SAN ANTONIO WATER SYSTEM
DSP Clayton Tank Replacement Project
SAWS Job No. 14-6101
Solicitation No. CO-00028

ADDENDUM NO. 5
November 5, 2015

The following changes, additions, and/or deletions are hereby made a part of the Contract Documents for the SAWS DSP Clayton Tank Replacement Project, for the San Antonio Water System, San Antonio, Texas, Dated October 2015, as fully and completely as if the same were set forth therein.

SHEET
C-SPS-18
SHEET 22 OF 99

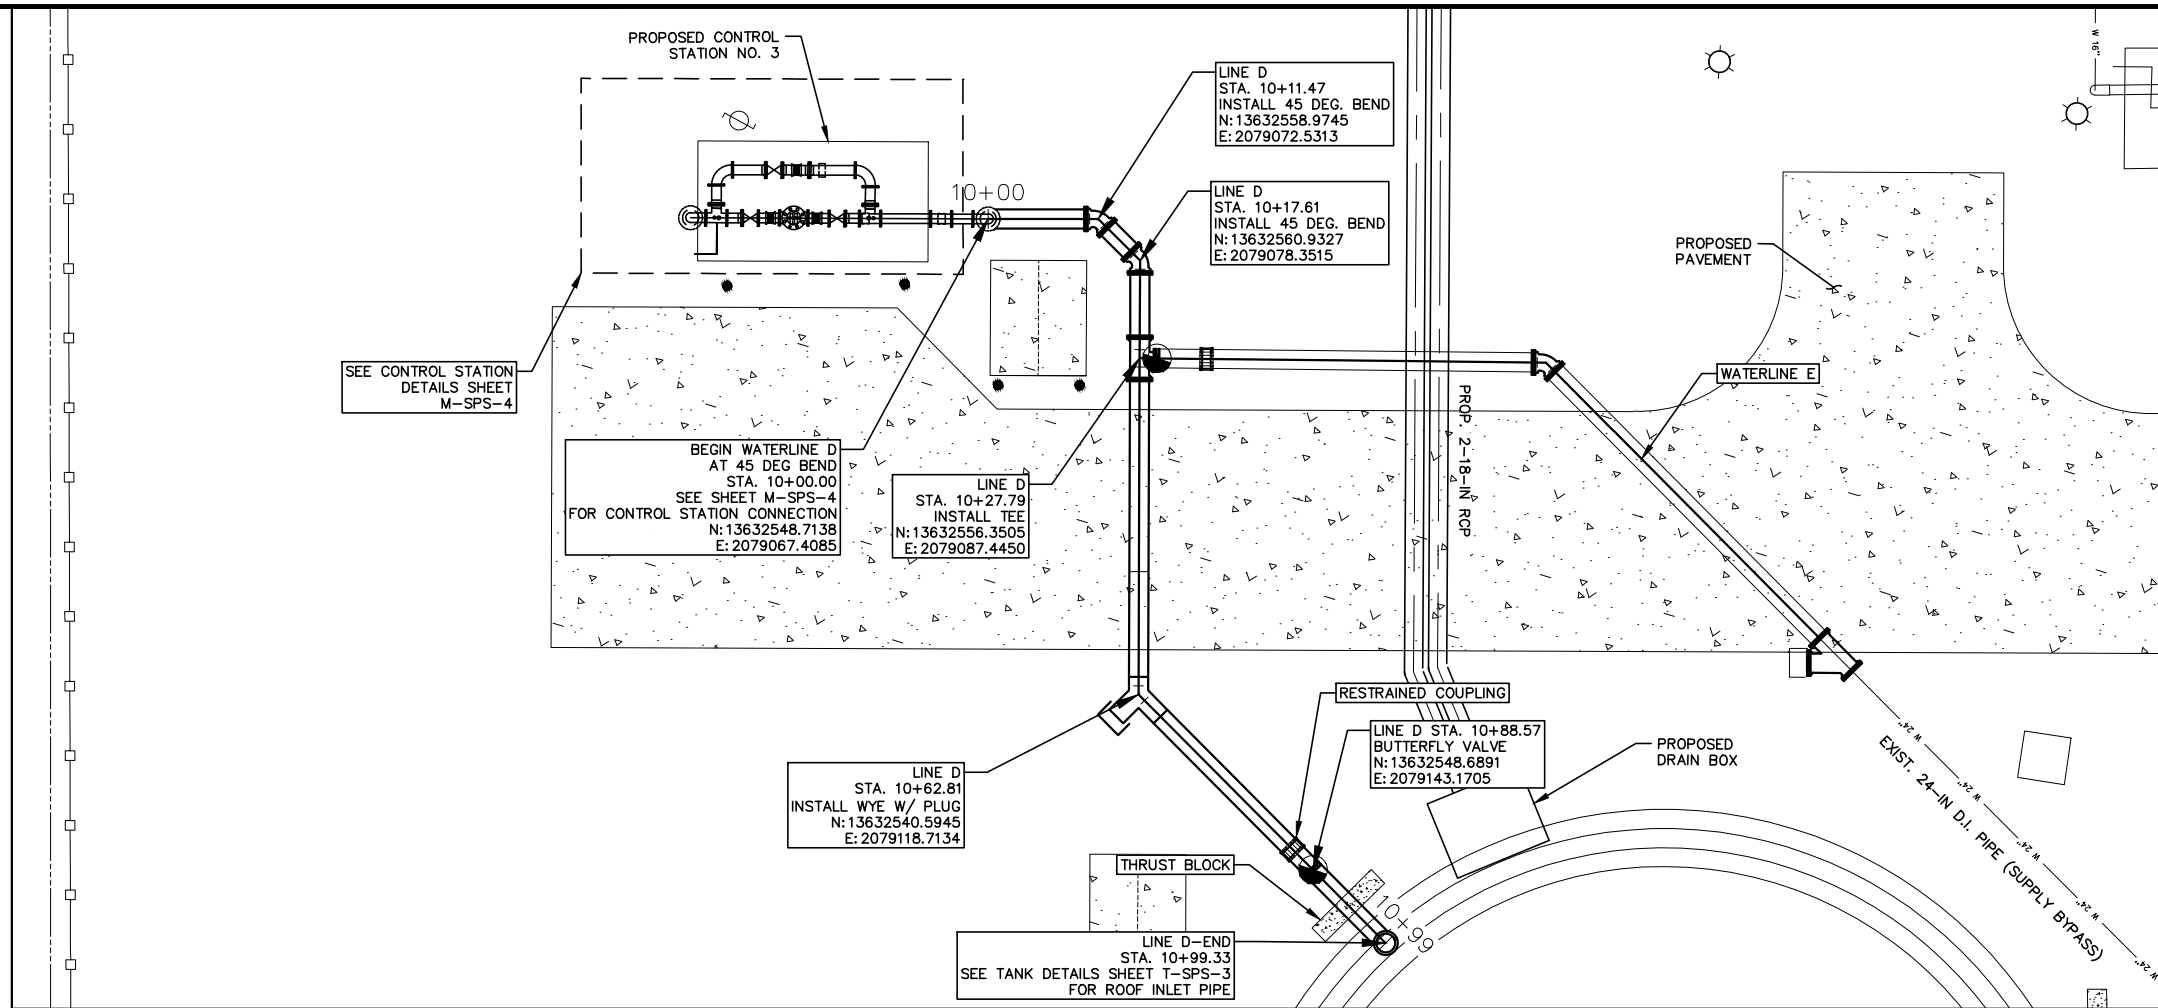
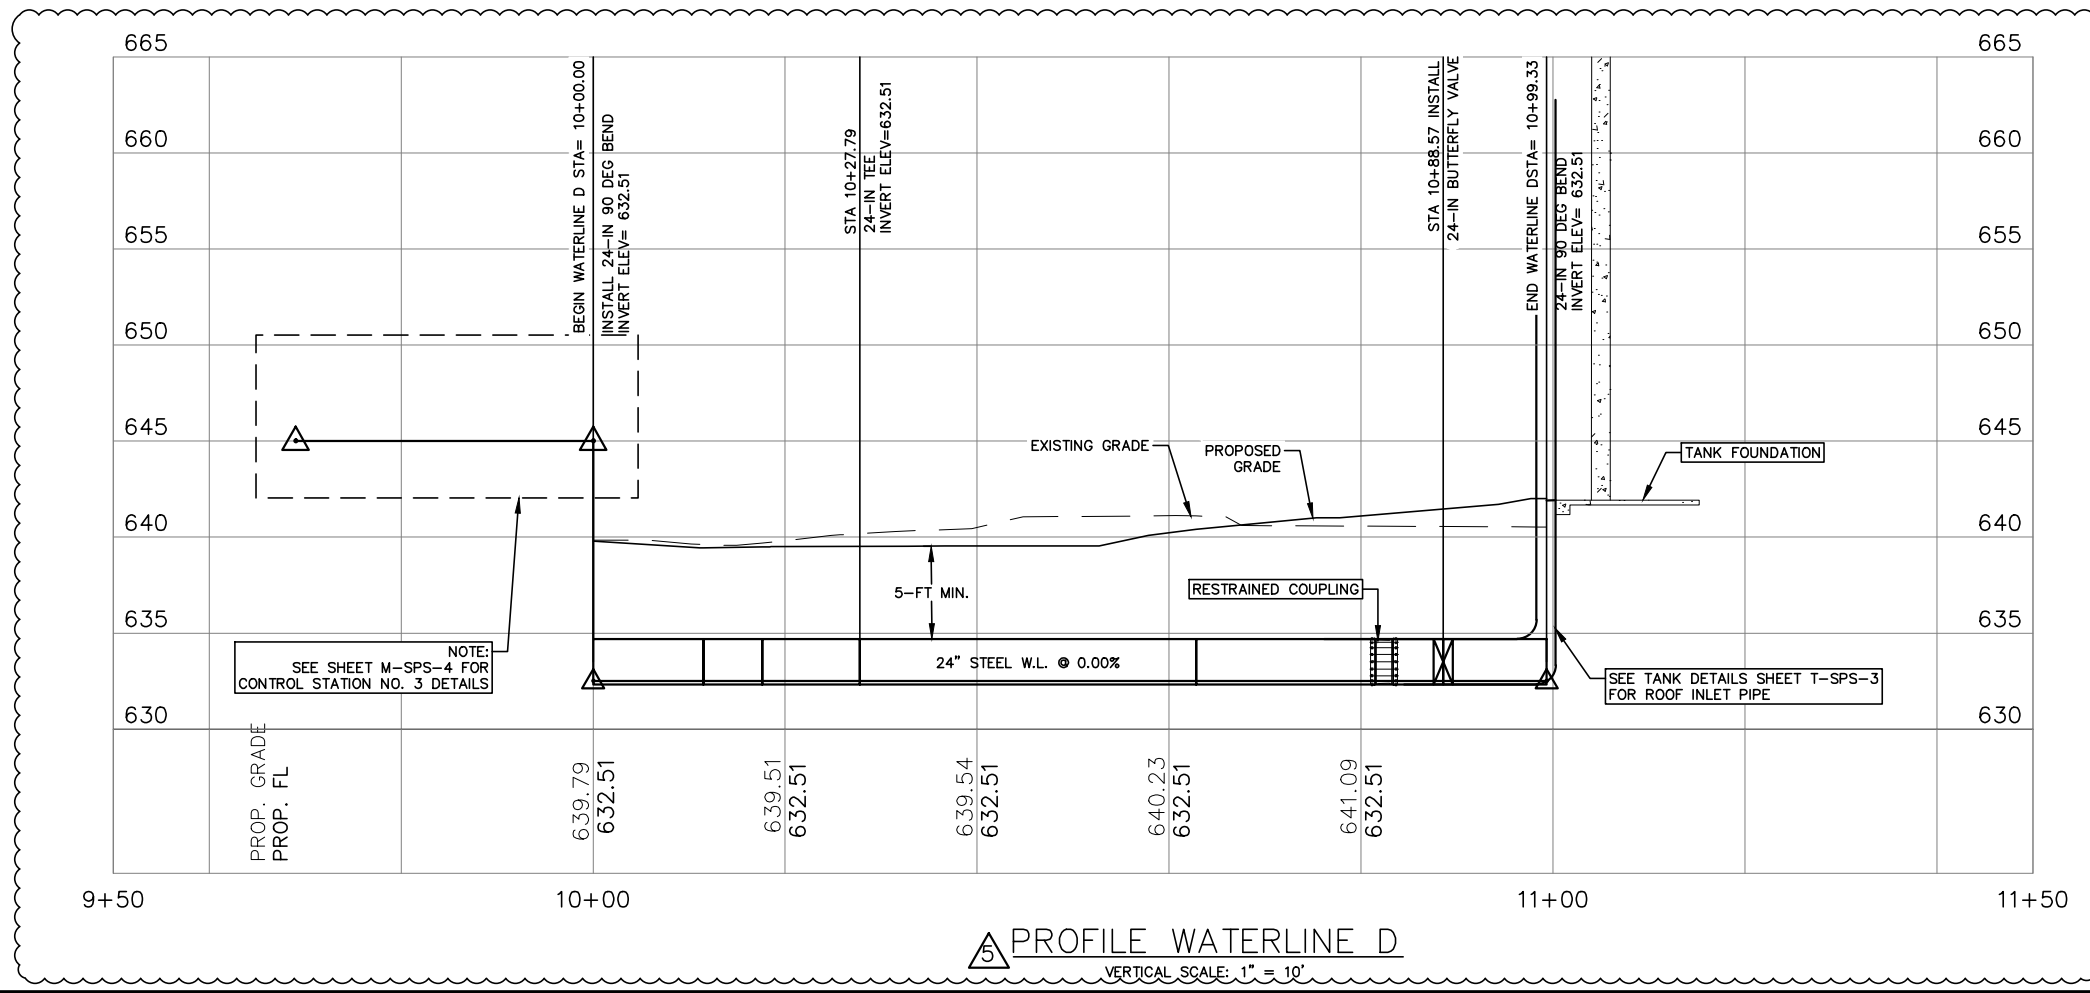
REMOVE AND REPLACE Sheet C-SPS-18 Proposed Yard Piping Plan & Profile IV (Sheet 22 of 99) in its entirety with the attached sheet.

5	ADDENDUM NO. 5 P.E. SEAL DATE	11.04.2015	W.C.C.	
5	REVISED WATERLINE D	11.04.2015	W.C.C.	
No.	Revision		Approved	Date

ELECTRICAL SITE PLAN-PROPOSED

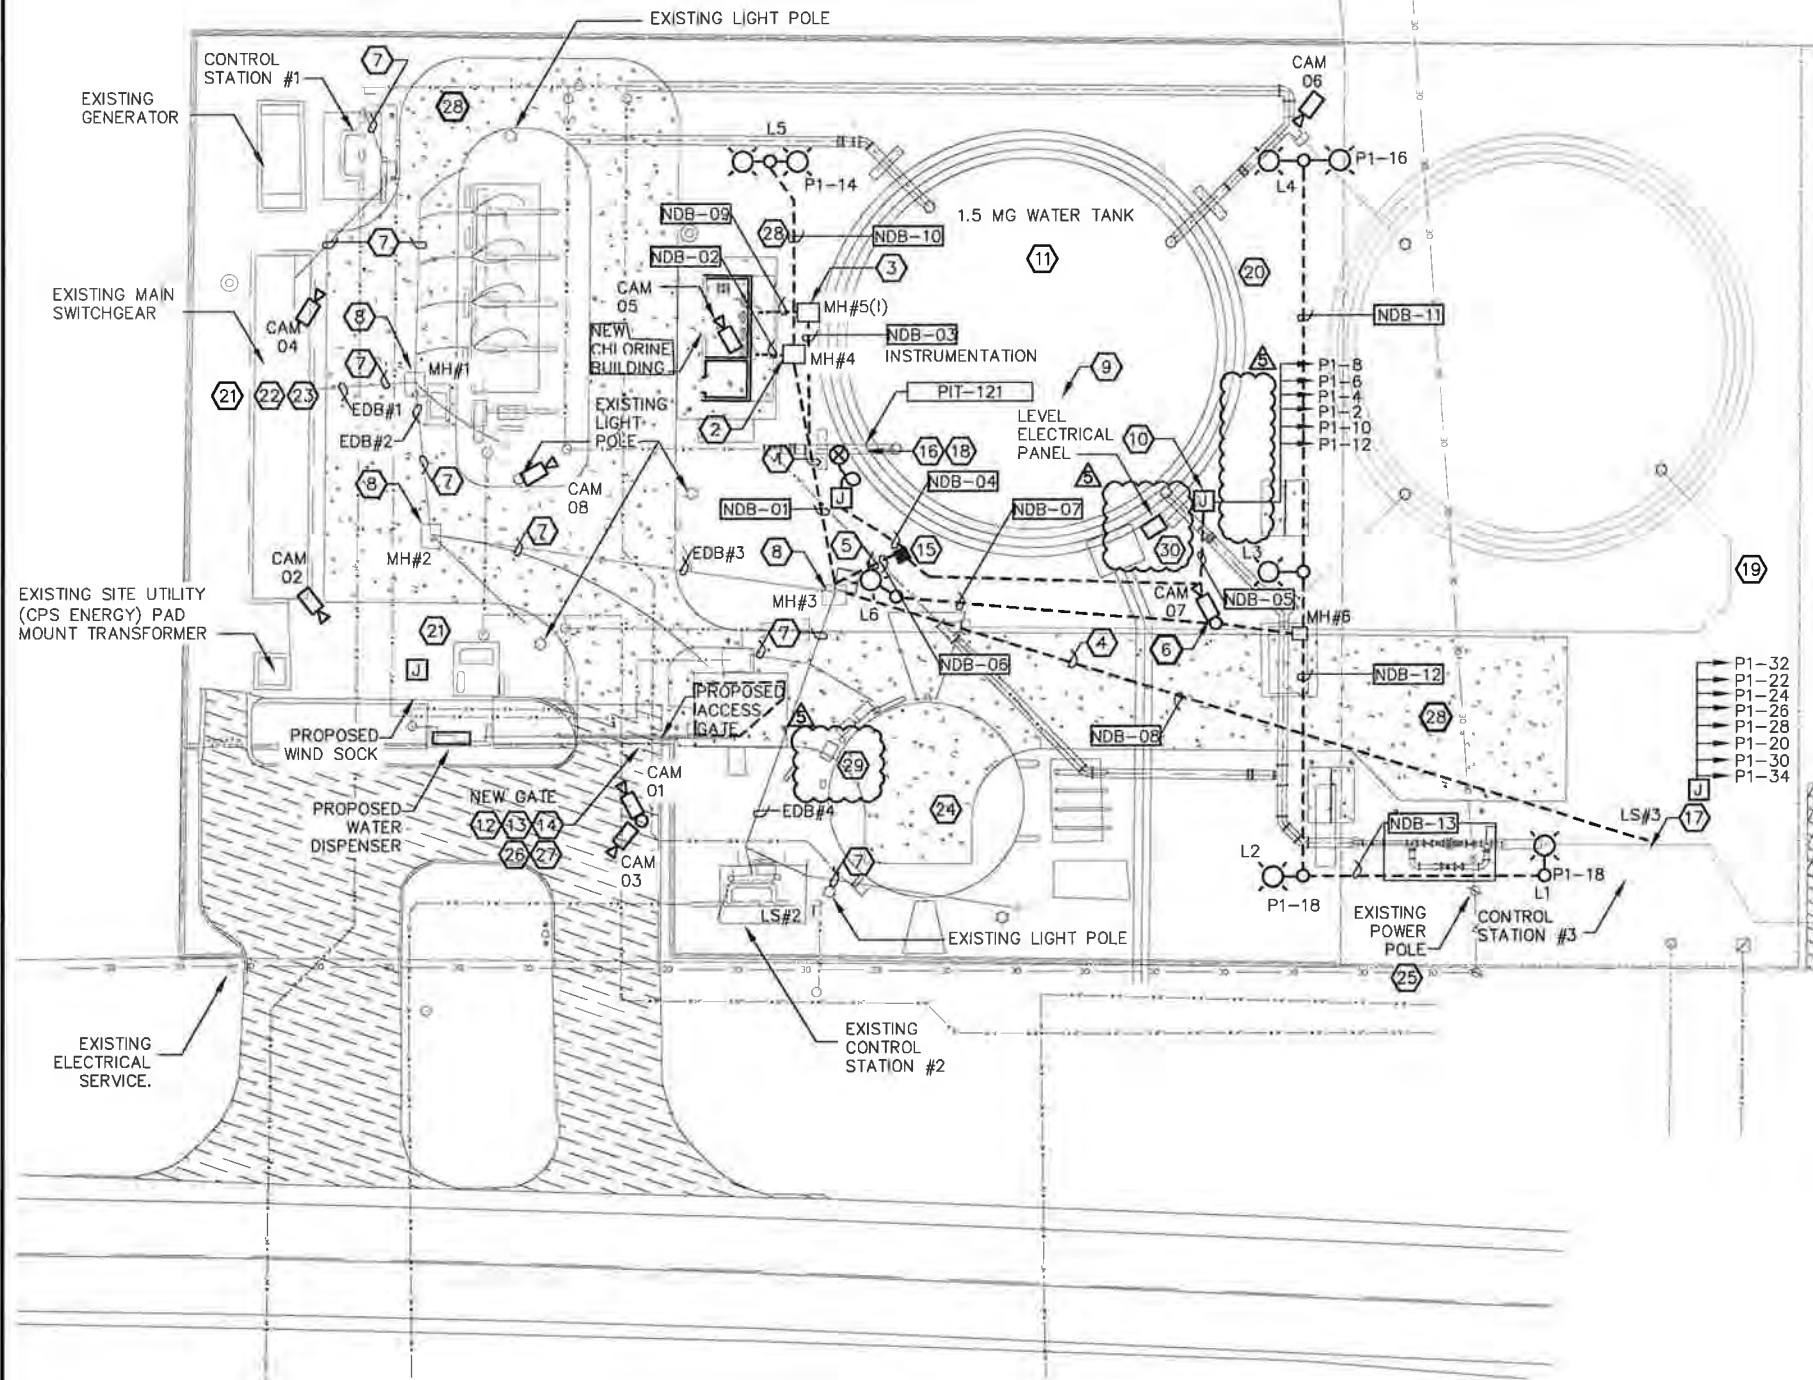
REMOVE AND REPLACE Sheet E-SPS-4 Electrical Site Plan – Proposed (Sheet 60 of 99) in its entirety with the attached sheet.

27. PROVIDE 2" SPARE EMPTY CONDUIT WITH NYLON PULL STRING FOR CONTROL WIRING TO GATE.
28. COORDINATE LOCATION OF LEAK DETECTORS PRIOR TO ANY WORK.
29. DEMOLISH LEVEL SWITCH LE-100, LE-101, LE-102. RETURN SWITCHES TO THE OWNER. RELOCATE LEVEL CONTROL PANEL AT NEW TANK SHOW ON NOTE 30. DEMOLISH LEVEL CONTROL PANEL POWER CABLES AND CONTROL WIRES.

30. PROVIDE NEW LEVEL SWITCHES AND INSTALL ON TANK. SWITCH SHALL BE B/W CONTROLS SERIES 6012-E554-13E ELECTRODE HOLDER. 6012-E554-13. CHECK MECHANICAL SHEET FOR ELEVATION. RELOCATE LEVEL CONTROL PANEL. PROVIDE POWER CABLES AND CONTROL WIRES CONTROL. WIRES SHALL BE (14)Ø#14 IN 1 1/2" C. PROVIDE ALL LEVEL CONTROL FUNCTION TEST.

SHEET
C-CPS-1
SHEET 90 OF 99

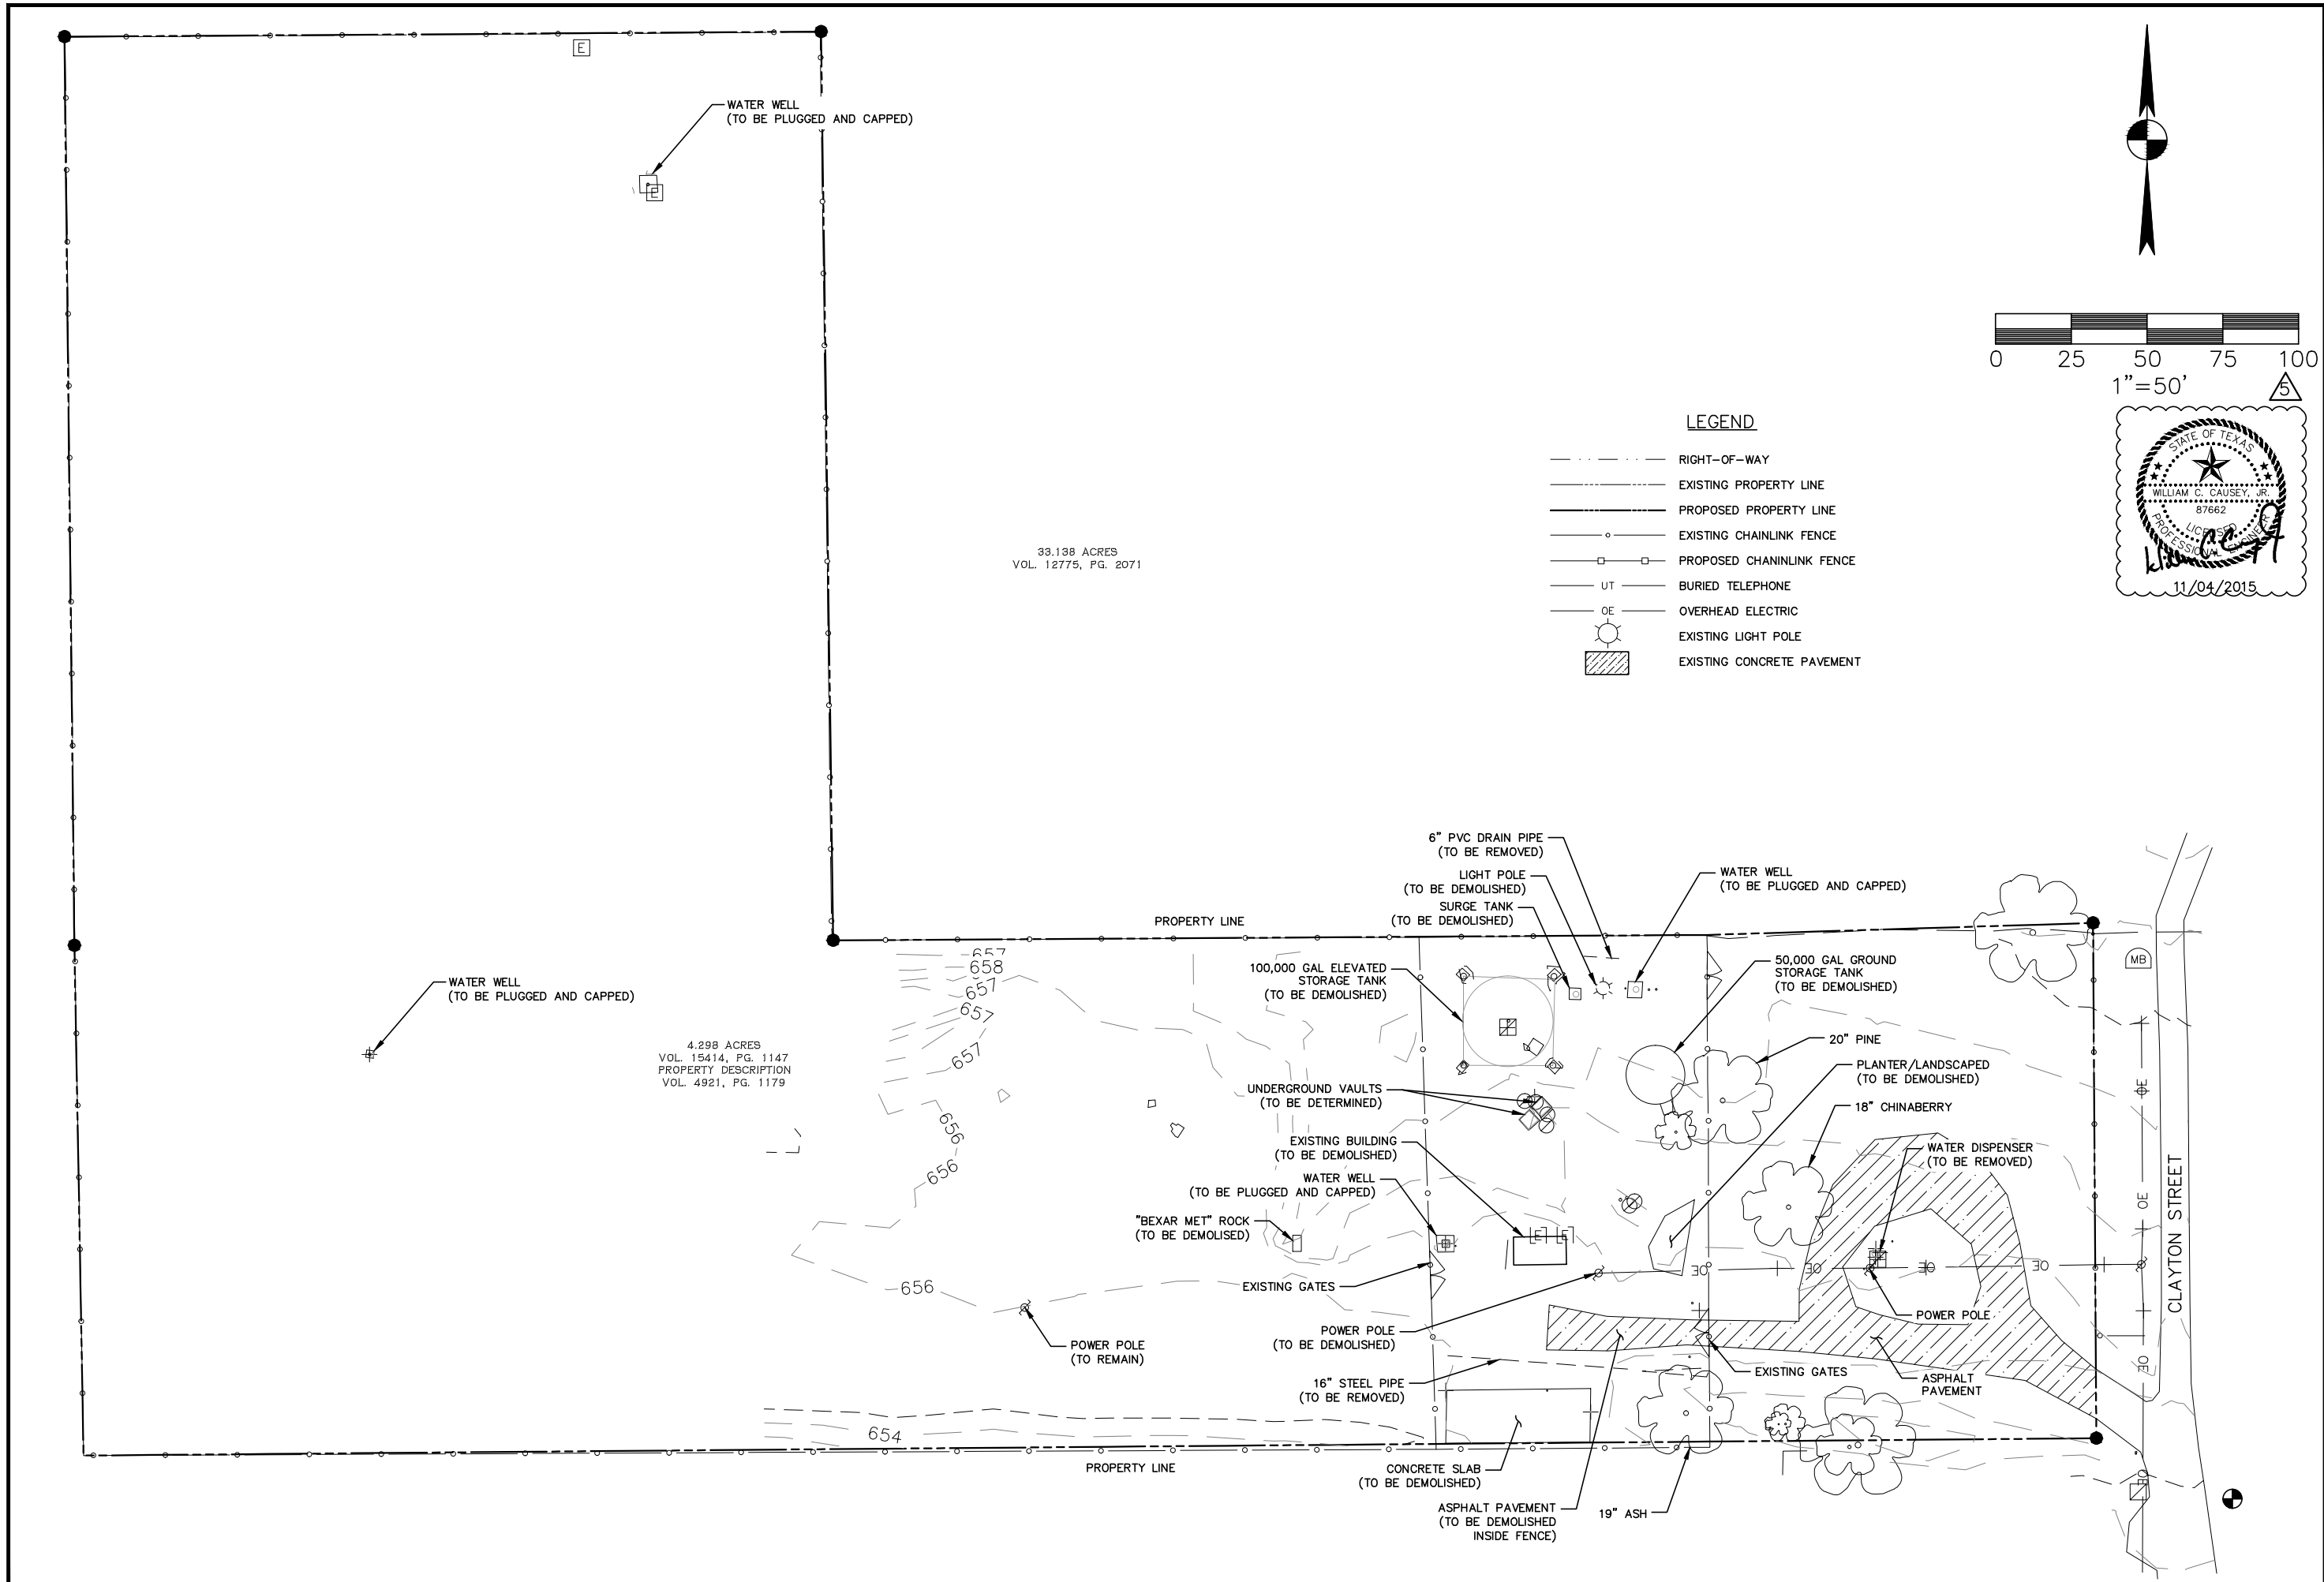
INCLUDE the attached Existing Clayton Facility Layout for reference of existing buried pipe at the Clayton Facility. CONTRACTOR is to demolish all below-grade piping and utilities as part of this project. Piping to be removed and plugged five (5) feet beyond property line.

CONTRACTOR shall conduct subsurface underground engineering to verify the locations, size, depths and materials of all existing underground utilities at no cost to the OWNER whether shown on the plans or not. Findings shall be documented by the contractor in the Record Drawings.
